Reference: Hanford Waste Vitrification Plant
DOE Contract DE-AC06-86RL10838
Fluor Contract 8457

NUMBER	REV	DATE	TITLE
DCN - #0115	0	10/22/93	REPOSITION FWX VALVES AT VARIOUS LOCATIONS & UPSIZE GFE WAREHOUSE FWX LINE
			"APPROVED FOR CONSTRUCTION"

FLUOR DANIEL US DEPARTMENT OF ENERGY HANFORD WASTE VITRIFICATION PLANT DESIGN CHANGE NOTICE	DCN - 0115	REV 0	PAGE 1 OF 10
	DCN TITLE Reposition FWX valves at various locations & UPSIZE GFE WARE- <i>HOUSE FWX LINE.</i>		DATE INITIATED 10/19/93 PACKAGE NO. CWBS-A160

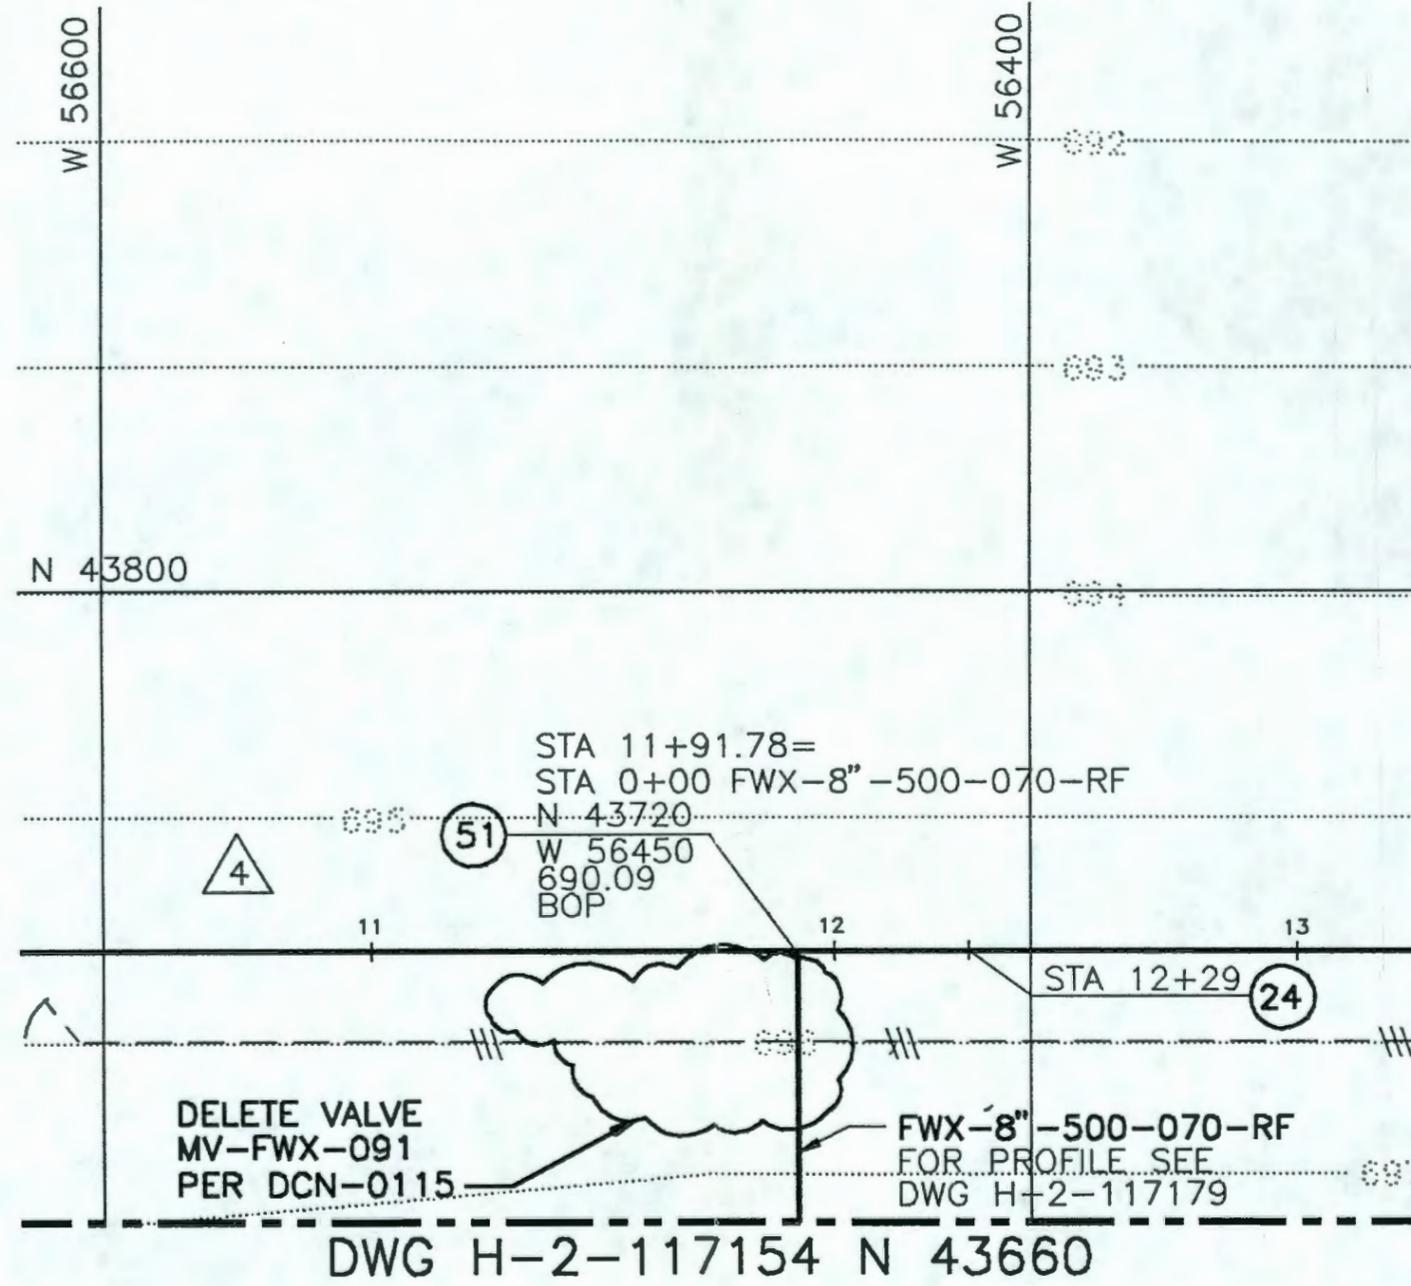
DELETED VALVE MV-FWX-081
PER DCN-0115

REMOVE END CAP
AND INSTALL 8" VALVE
PER DCN-0115

BASE DOC. NO. H-2-117154
SHT/PG. 1 REV. 4
CR NO. CR-HWVP-1056R1
DISCIPLINE: CIVIL

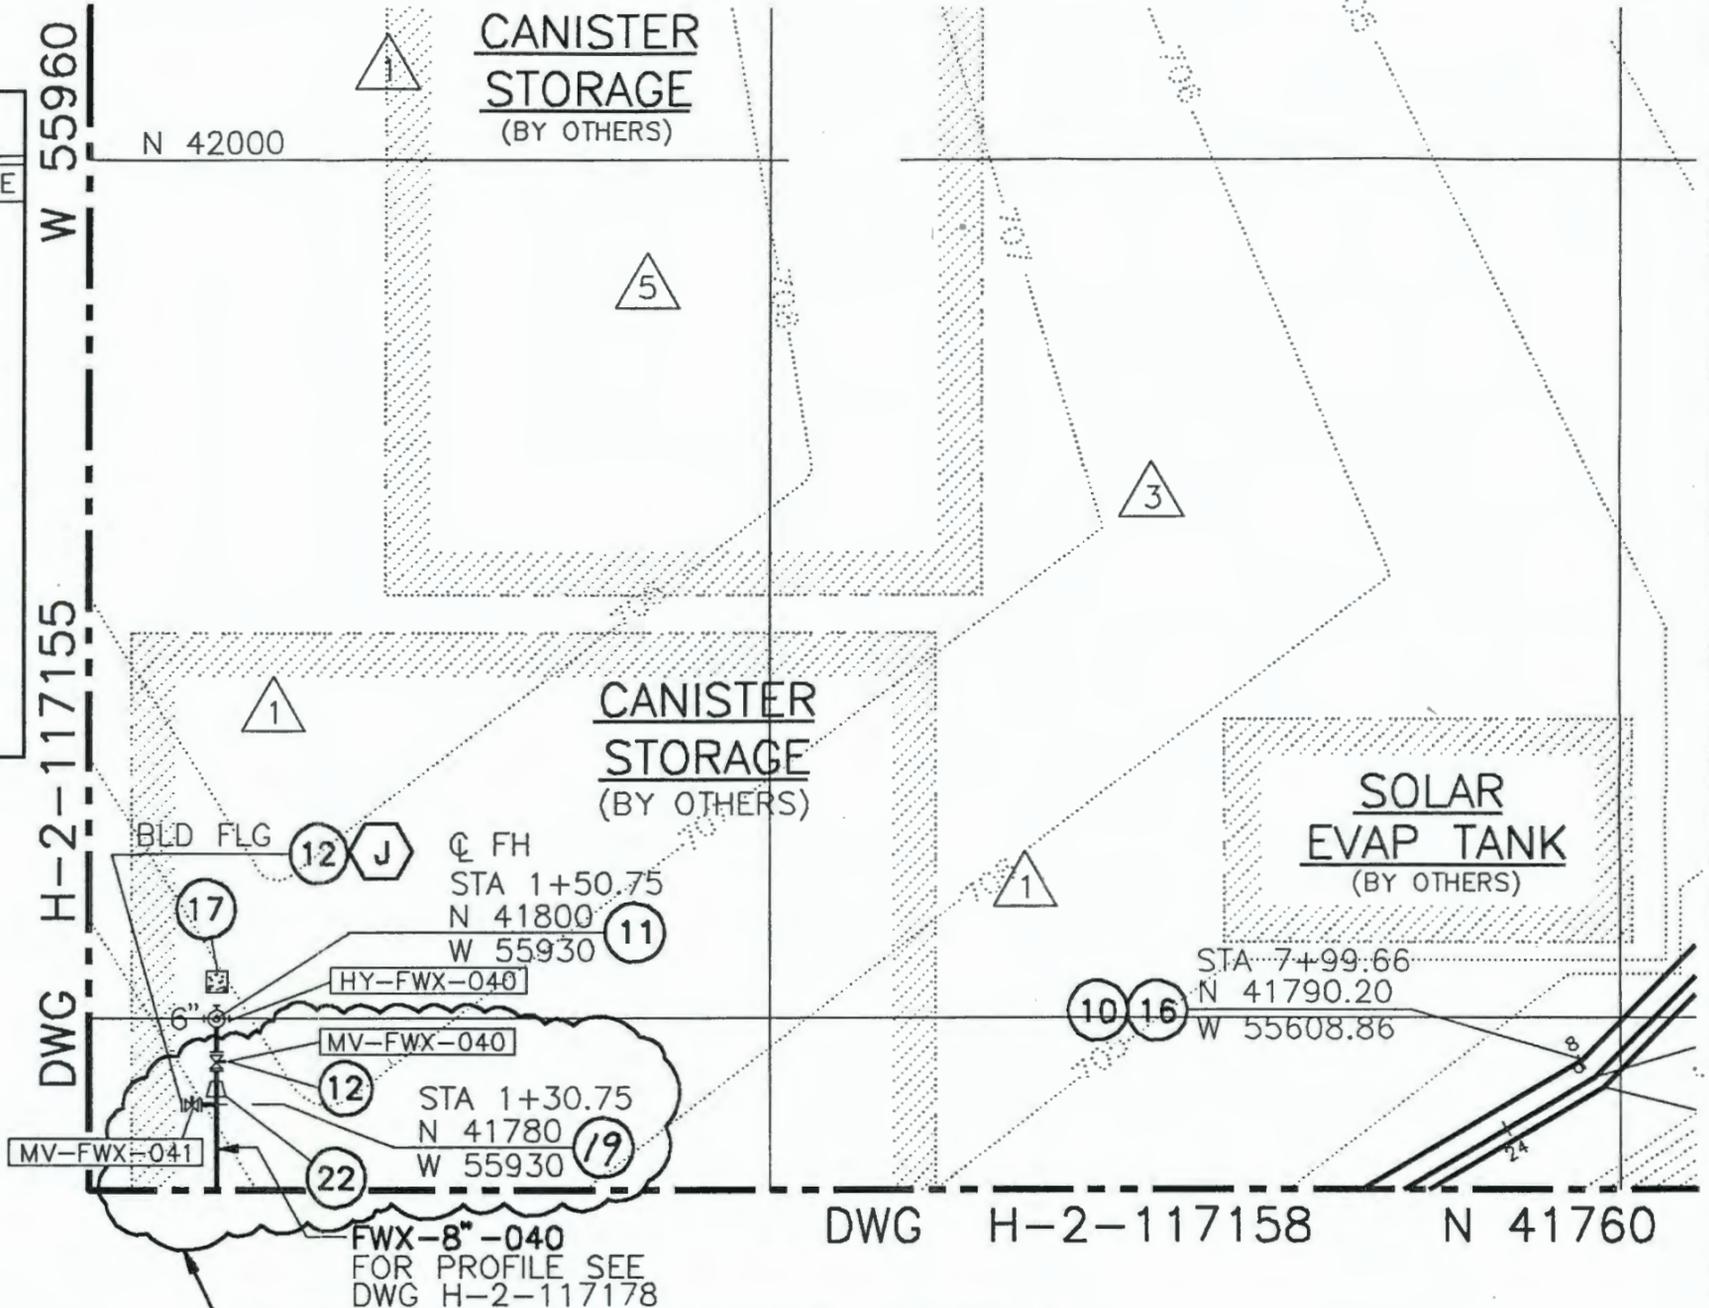
INSTALL 8" VALVE & UPSIZE
PER DCN-0115 LINE TO
8"

PER DCN-0115

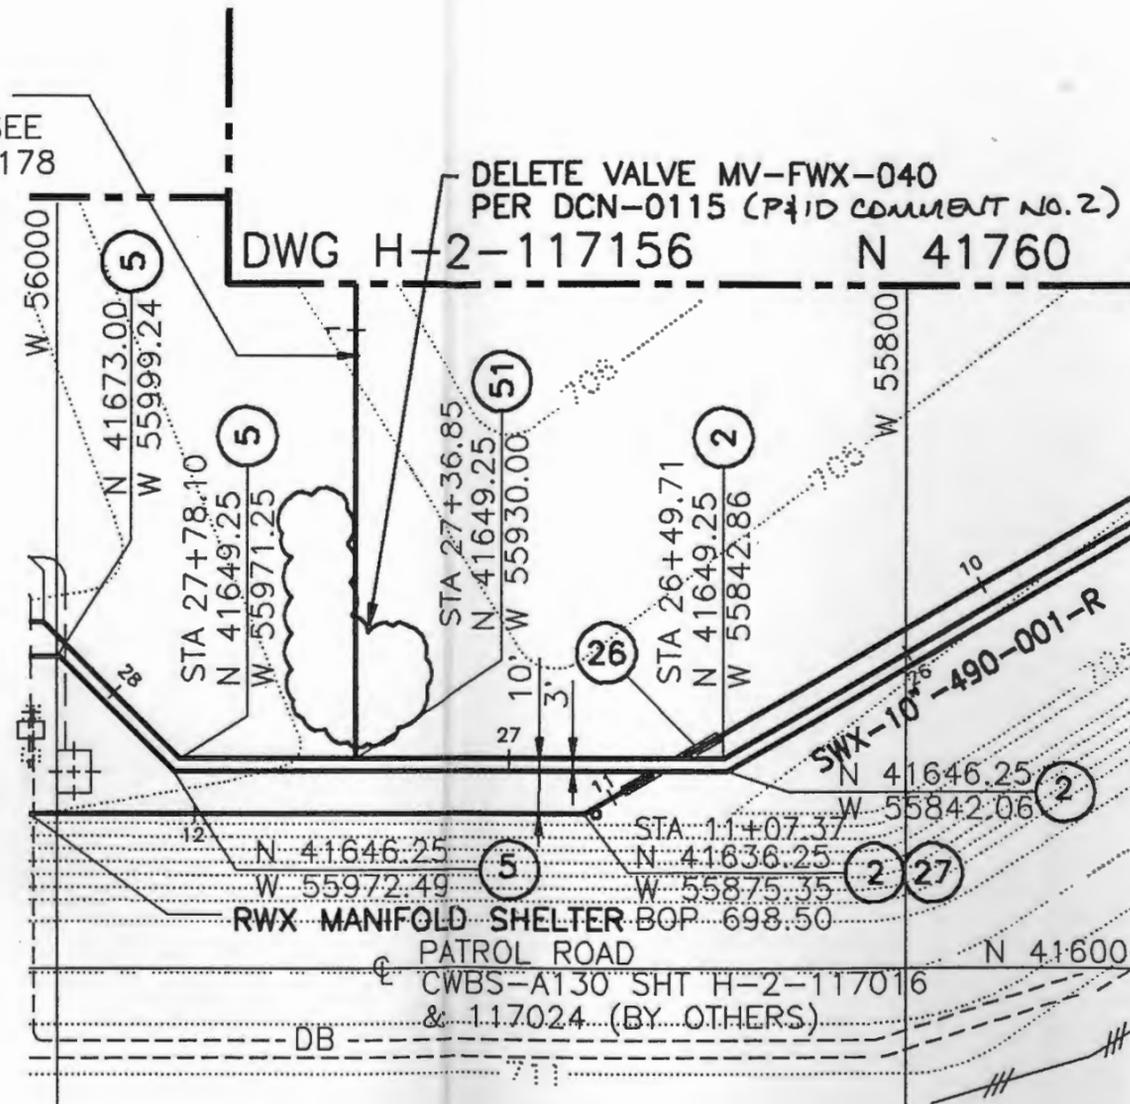
INSTALL MV-FWX-040 AND ADJUST LOCATION OF
FWX CONNECTION AT COORDINATE
PER DCN-0115 (PID COMMENT NO.2) J

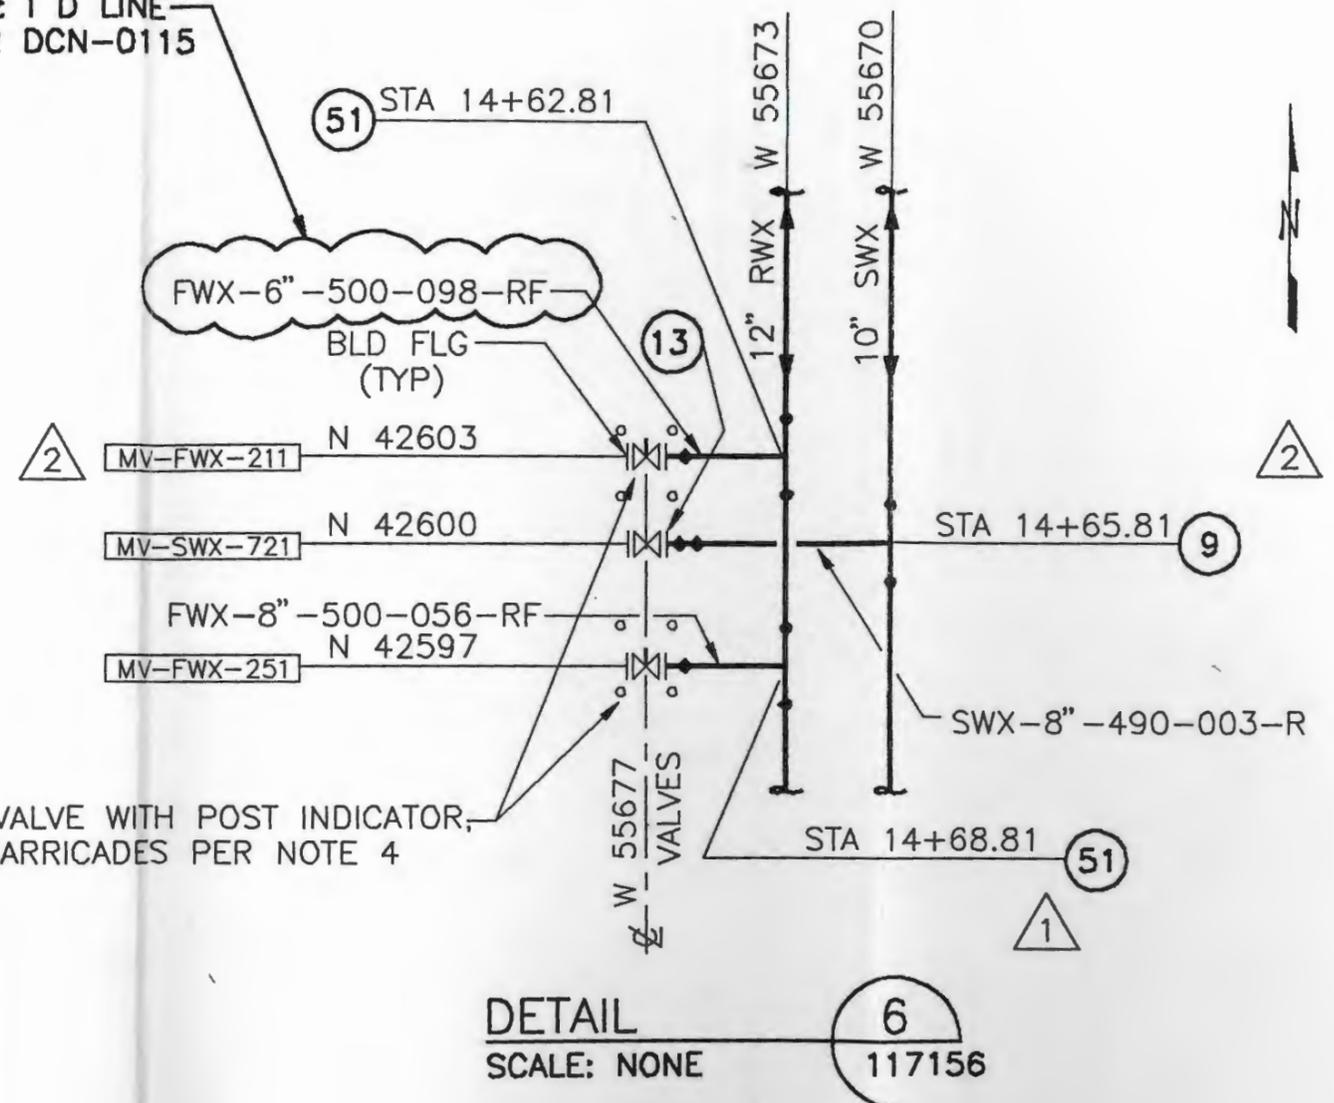
DELETE VALVE MV-FWX-040
PER DCN-0115 (P&ID COMMENT NO. 2)
DWG H-2-117156 N 41760

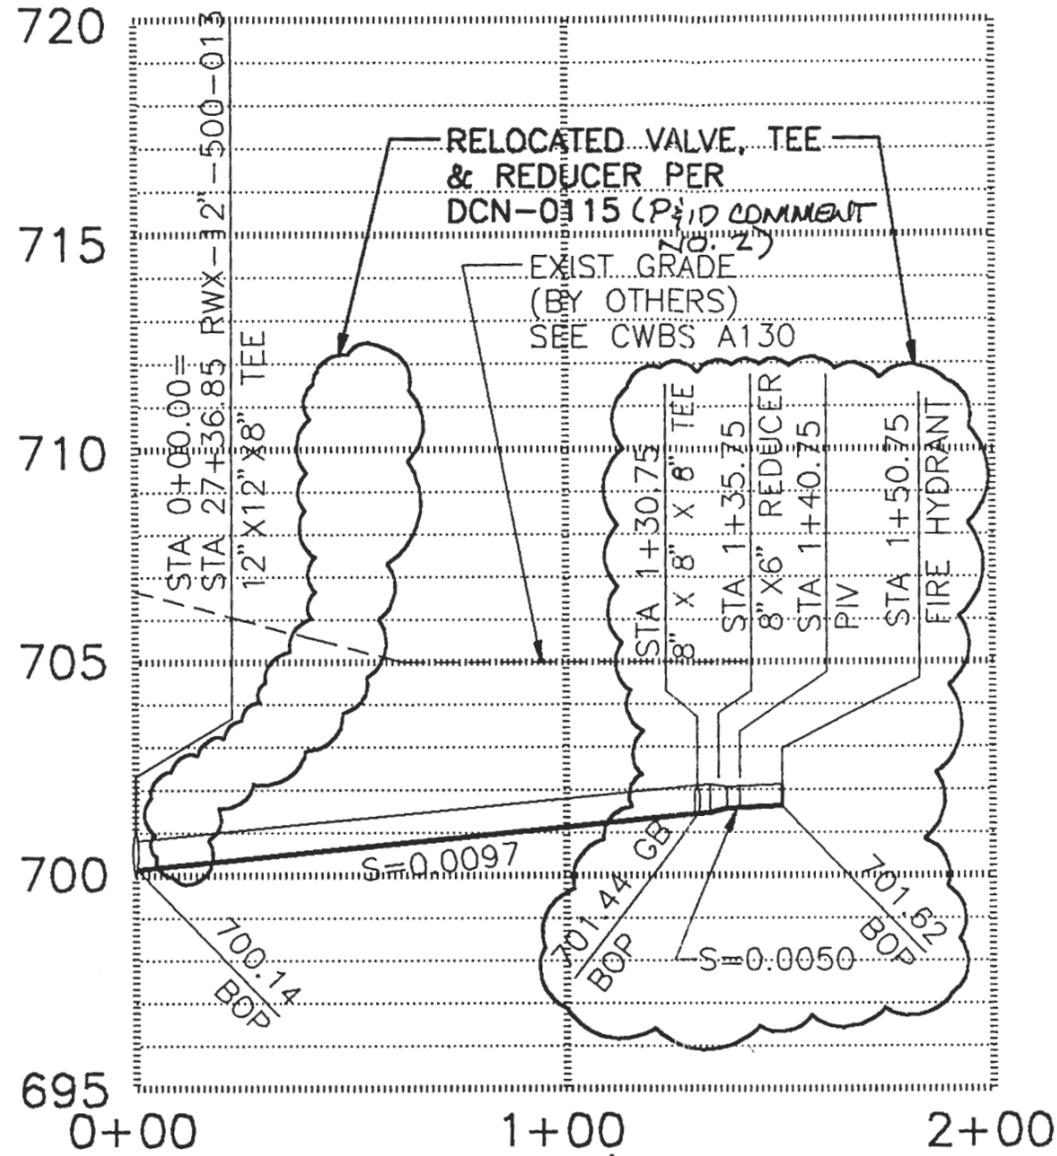
REVISED P & I D LINE
NUMBER PER DCN-0115

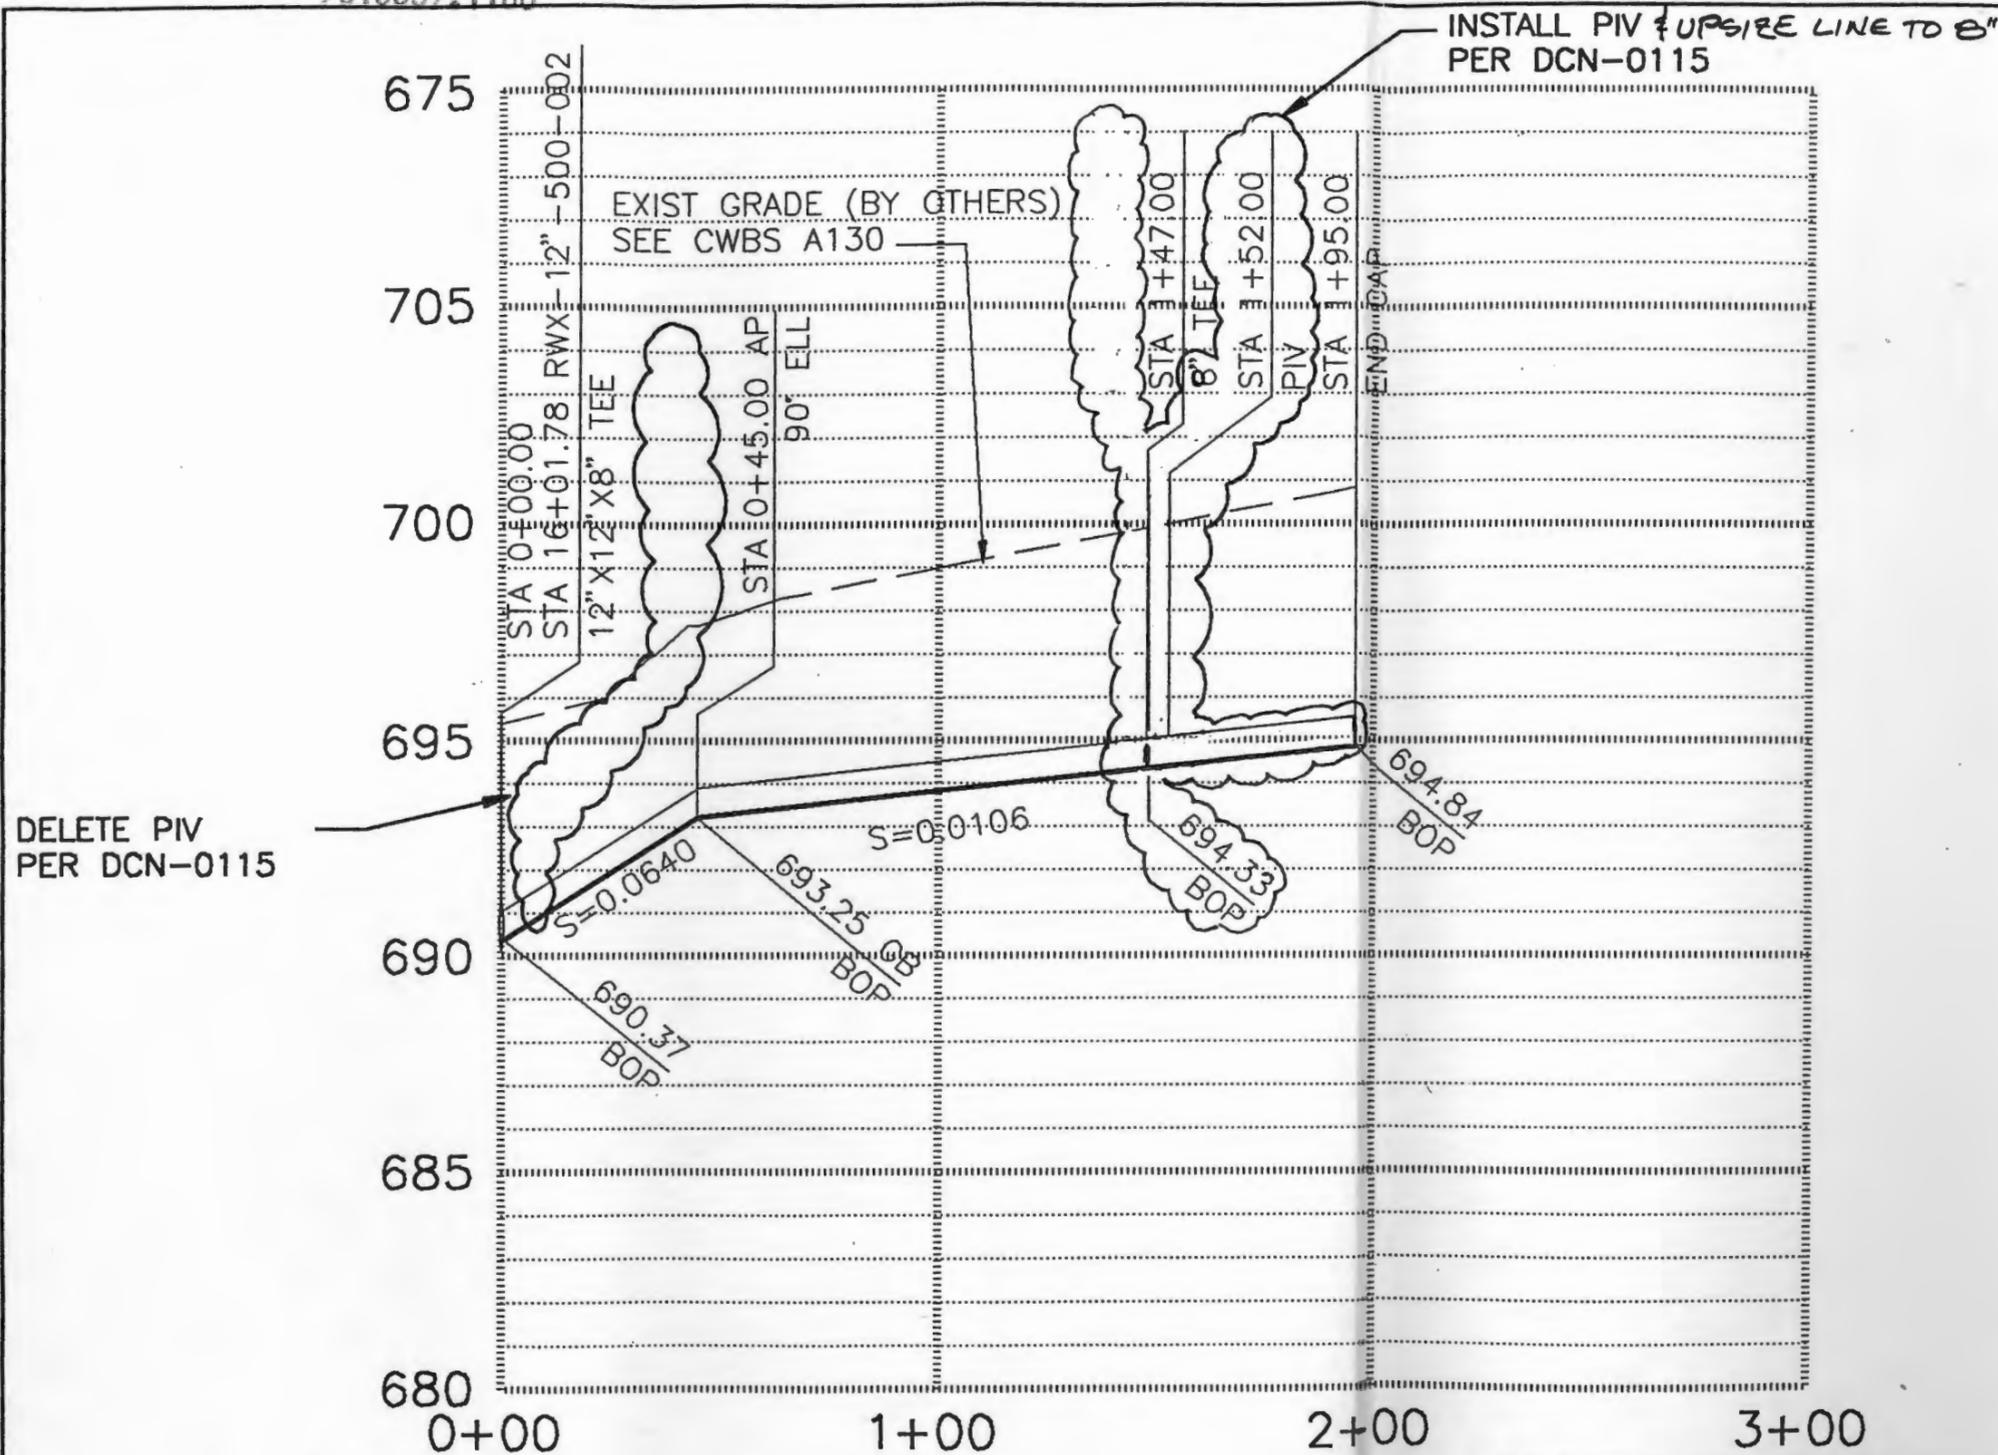
DELETE PIV
PER DCN-0115

INSTALL PIV & UPSIZE LINE TO 8"
PER DCN-0115
